ADDENDUM NO. 03

Three Rivers Community Schools District Signage 700 Sixth Avenue Kalamazoo, MI 49093

OWNER THREE RIVERS COMMUNITY SCHOOLS **PROJECT** DISTRICT SIGNAGE PACKAGE A/E Project 5-6405 **ADDENDUM 003 PURPOSE** THIS ADDENDUM SHALL FORM PART OF THE BIDDING DOCUMENTS. CHANGES, ADDITIONS, CLARIFICATIONS OR DELETIONS HEREIN SUPERSEDE THE DRAWINGS AND SPECIFICATIONS. BIDDERS SHALL INCLUDE ON THE PROPOSAL FORM ACKNOWLEDGEMENT OF THE RECEIPT OF THIS ADDENDUM. **ATTACHMENTS New Specifications: None** Reissued Specifications: 10 14 26 New Sheets: C2.06 Reissued Sheets: G0.00, G2.01, C2.01, C2.02, C2.03, C2.04, C2.05 ARCHITECT-ENGINEER **GMB** www.gmb.com 616.796.0200 **CONSTRUCTION MANAGER** THE SKILLMAN CORPORATION www.skillman.com 269.350.5757

G2.01

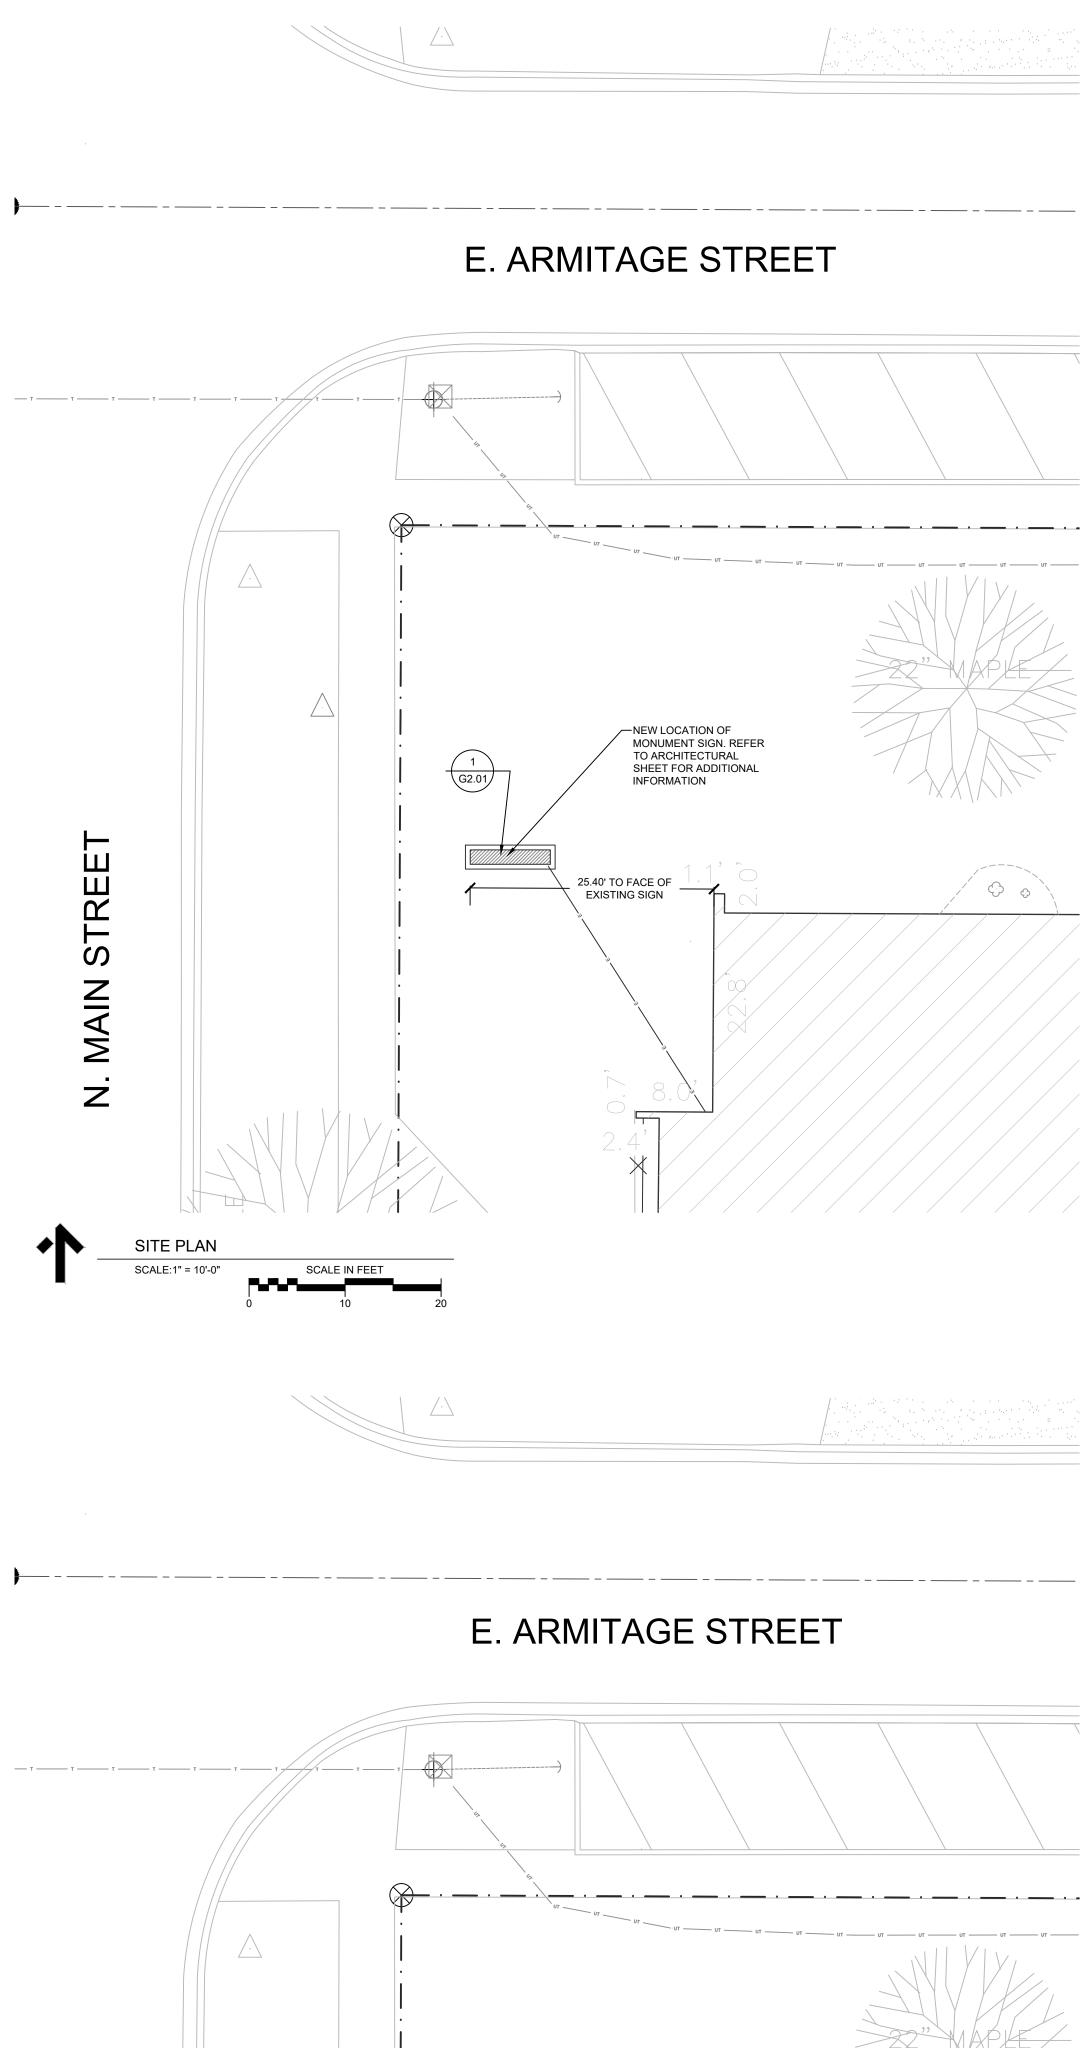
<u>ITEM NO. 3</u> <u>SHEET G2.01 – SIGN ELEVATIONS (**REISSUED**)</u>

- A. Added signage for Norton Elementary (5/G2.01) to signage sheet.
- B. Revised notes on 4/G2.01.
- C. Revised layout of 6/G2.01.

DEMOLITION AND SITE PLANS AT RUTH HOPPIN ELEMENTARY

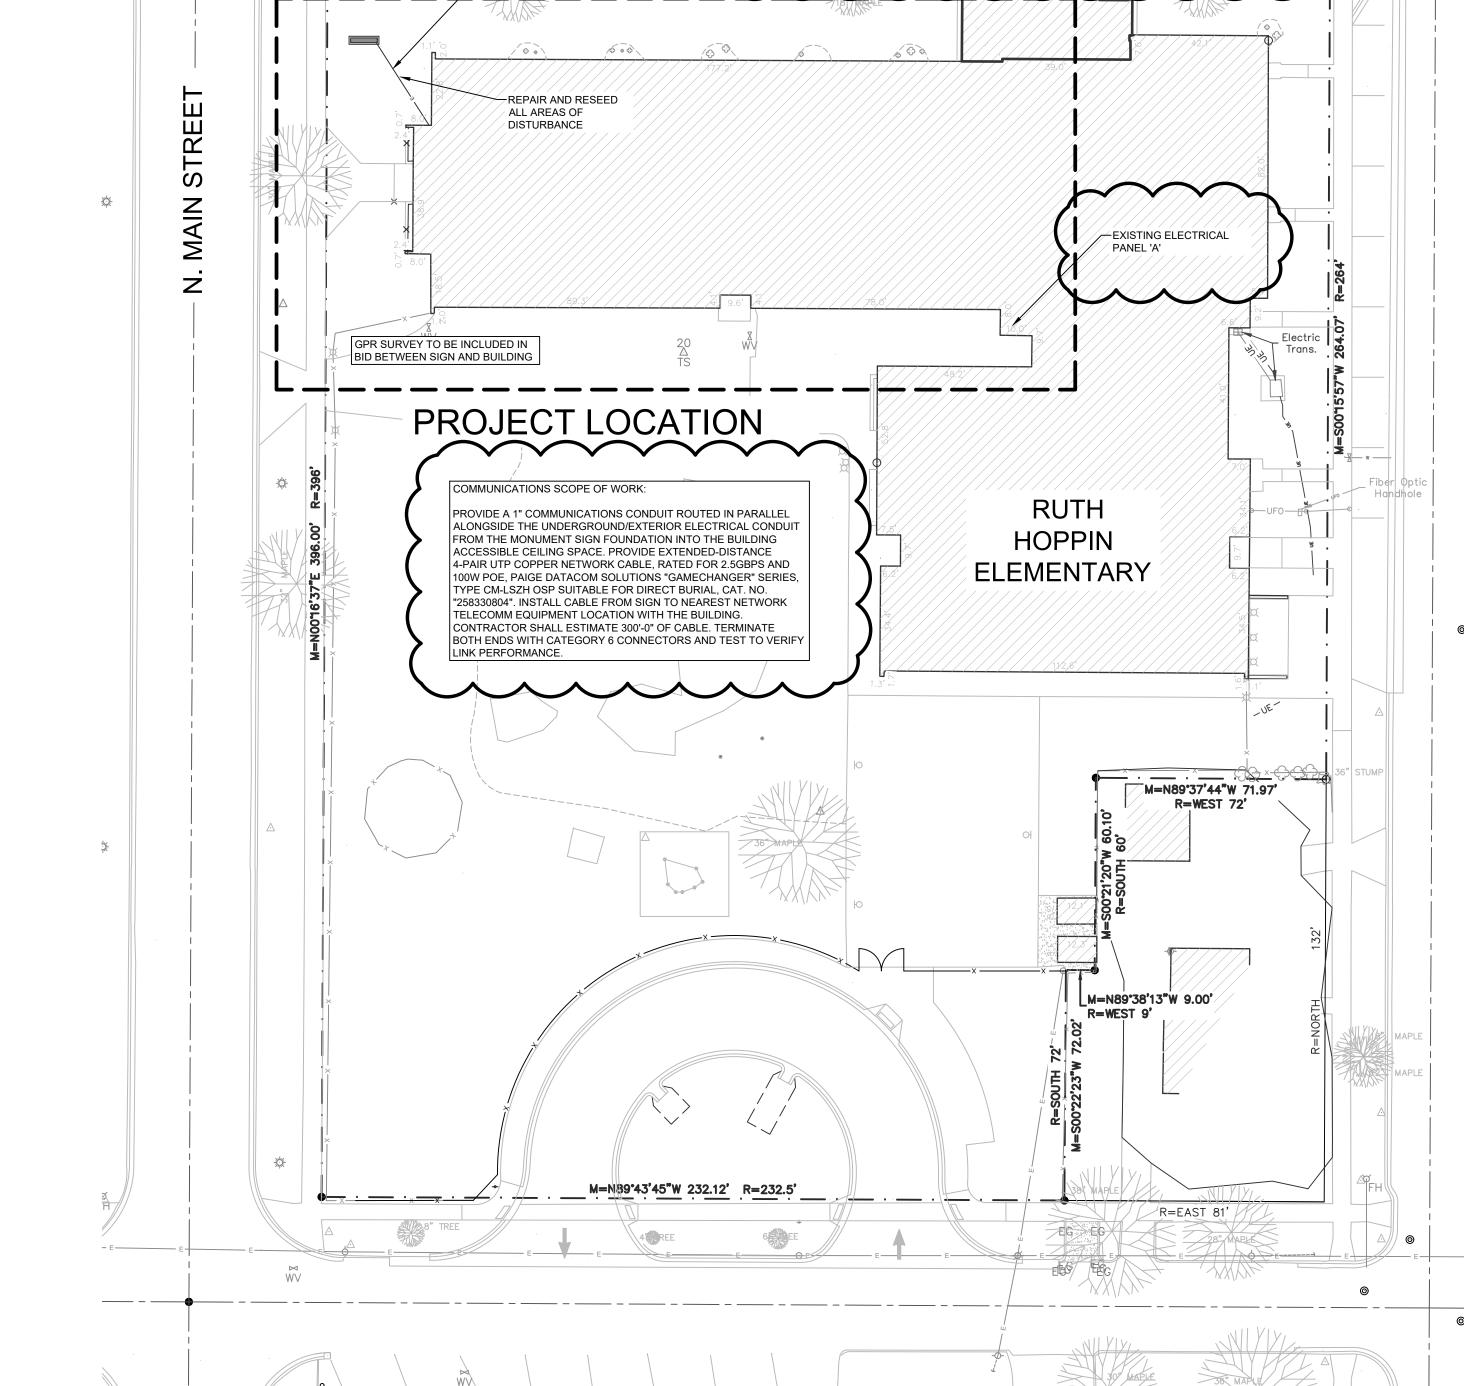
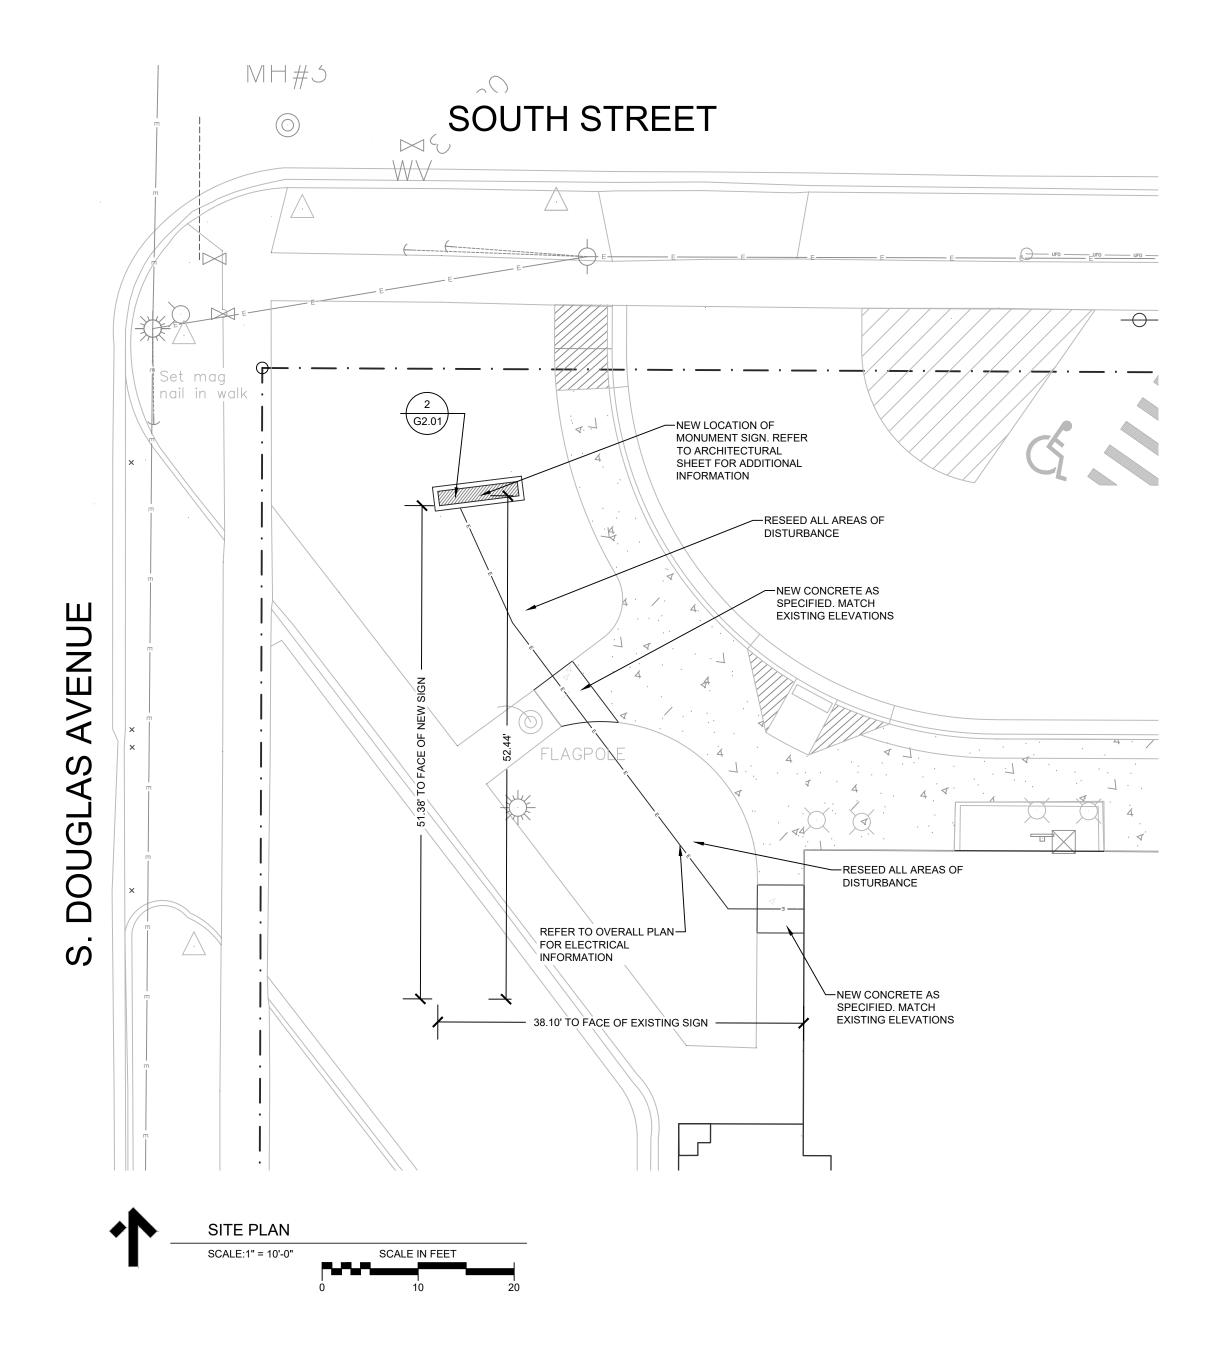
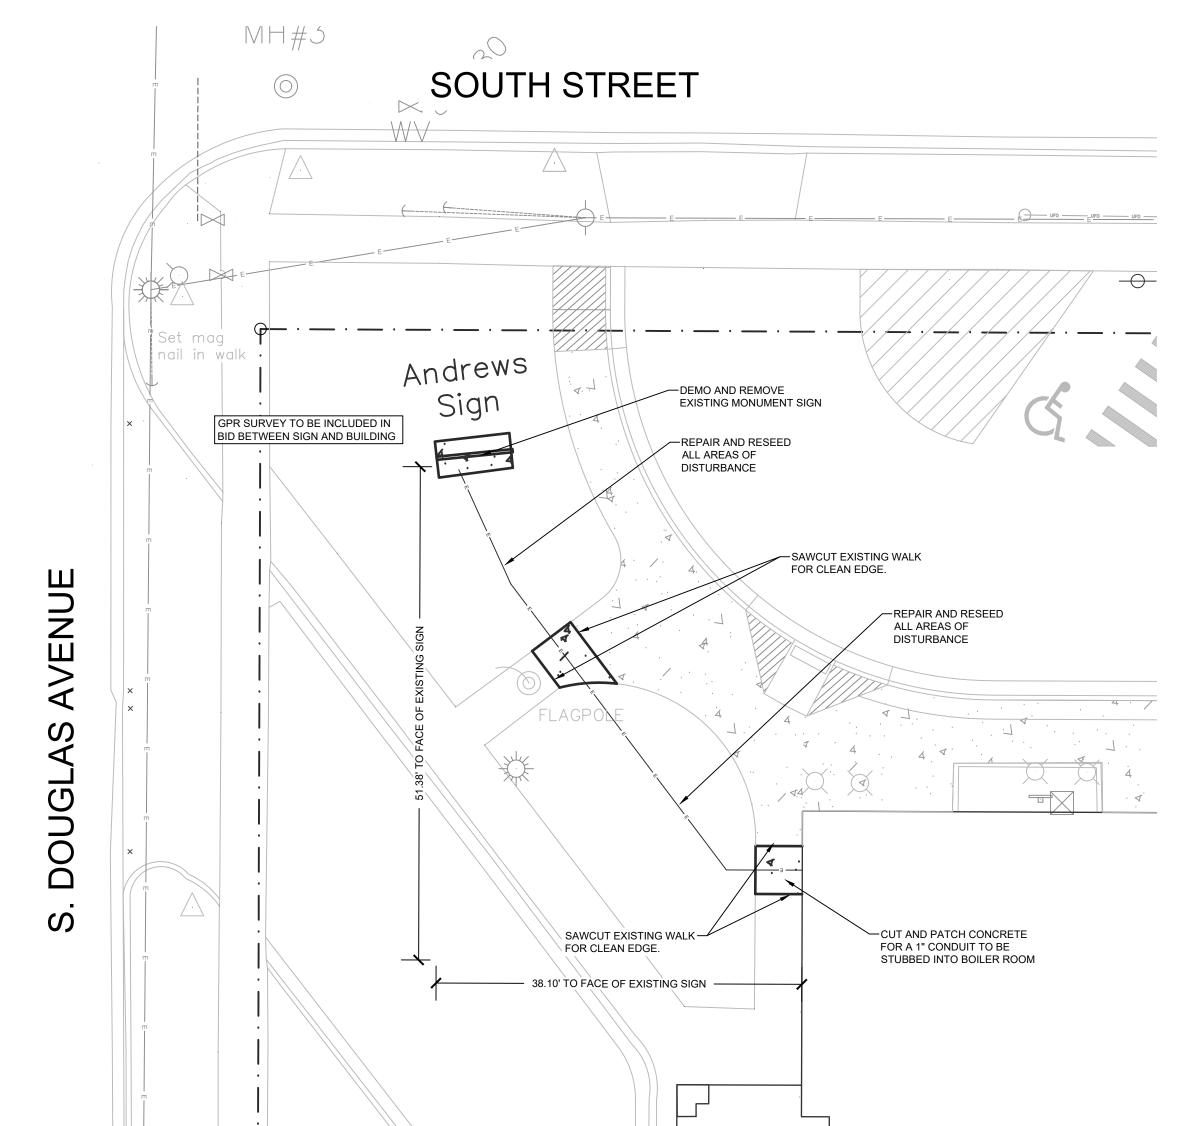
ITEM NO. 4 SHEET C2.01 – DEMOLITION AND SITE PLANS AT RUTH HOPPIN ELEMENTARY (REISSUED)

Revised electrical and communications requirements to serve monument sign.

PROVIDE A NEW MULTI-WIRE BRANCH CIRCUIT TO SERVE MONUMENT SIGN WITH ELECTRONIC MESSAGE

- ORIGIN: EXISTING PANELBOARD 'A' AS INDICATED ON PLAN; PROVIDE 3P/20A CIRCUIT BREAKER.

- PROVIDE A NEMA 3R 3-POLE HEAVY DUTY SAFETY SWITCH (NOT FUSIBLE) FOR DISCONNECTING MEANS; MOUNT TO THE END OF THE SIGN NEAREST THE BUILDING AND WIRE BRANCH CIRCUIT

- CONNECT ALL LOADS 120VAC LINE-TO-NEUTRAL ACROSS THE MULTI-WIRE BRANCH CIRCUIT --MESSAGE CENTER #1 (PHASE A), MESSAGE CENTER #2 (PHASE B), ILLUMINATED SIGN CABINET - PROVIDE LOCAL GROUNDING ELECTRODE PER SPECIFICATION AT SIGN, BOND ELECTRODE AND
